HIGHWAY CONSTRUCTION BID PLANS OF PROPOSED ^{FINAL} FEDERAL AID PROJECT NO. IM-0703-322 STATE HIGHWAY NO. 70 EISENHOWER/JOHNSON MEMORIAL TUNNEL PANEL REPLACEMENT PROJECT - *ESMT-South Tunnel* SUMMIT AND CLEAR CREEK COUNTIES CONSTRUCTION PROJECT CODE NO. 16102

EISENHOWER/JOHNSON MEMORIAL TUNNEL
 PANEL REPLACEMENT PROJECT
 SUMMARY OF APPROXIMATE FINAL
 QUANTITIES
 Designer: J. BRAAKSMA Structure F-13-X
 Detailer: J. SPANIER Numbers
 Sheet Subset: Subset Sheets: S-2 OF S-19

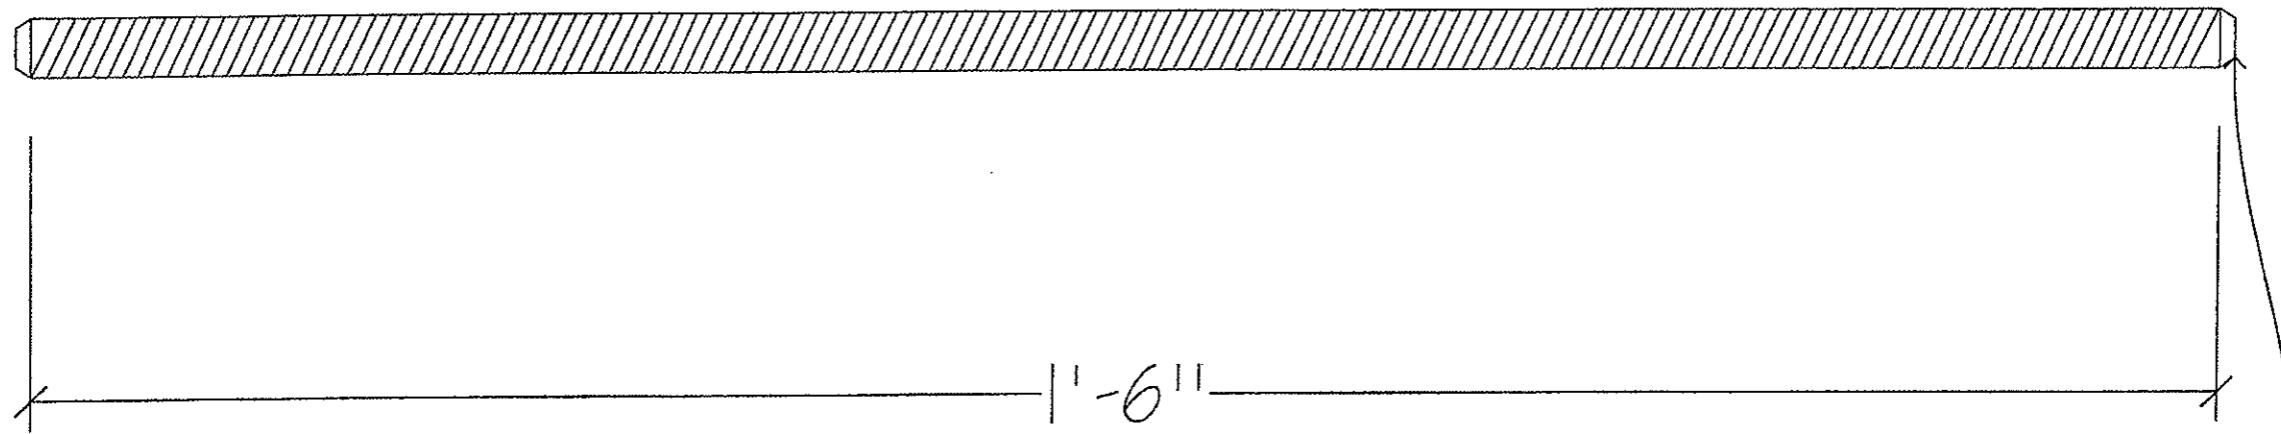
All cut ends of threaded rod to be chamfered typ.

232 Additional $\frac{1}{2}$ " threaded rods to be cut, verify length with field measurment.

SECTION A

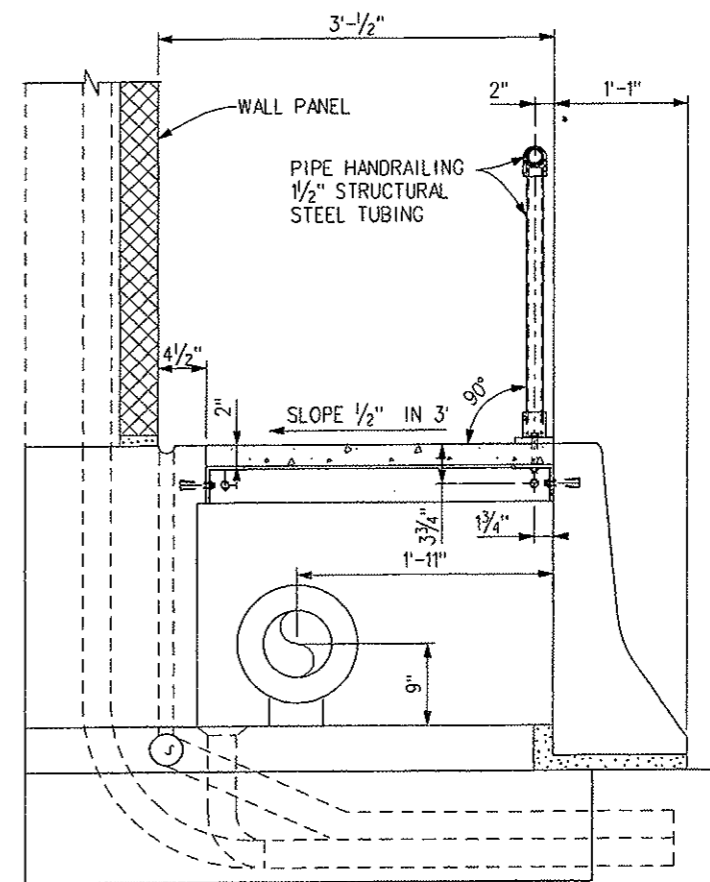
SEE PAGE 17A FOR NEW PIPE HANDRAIL DETAIL
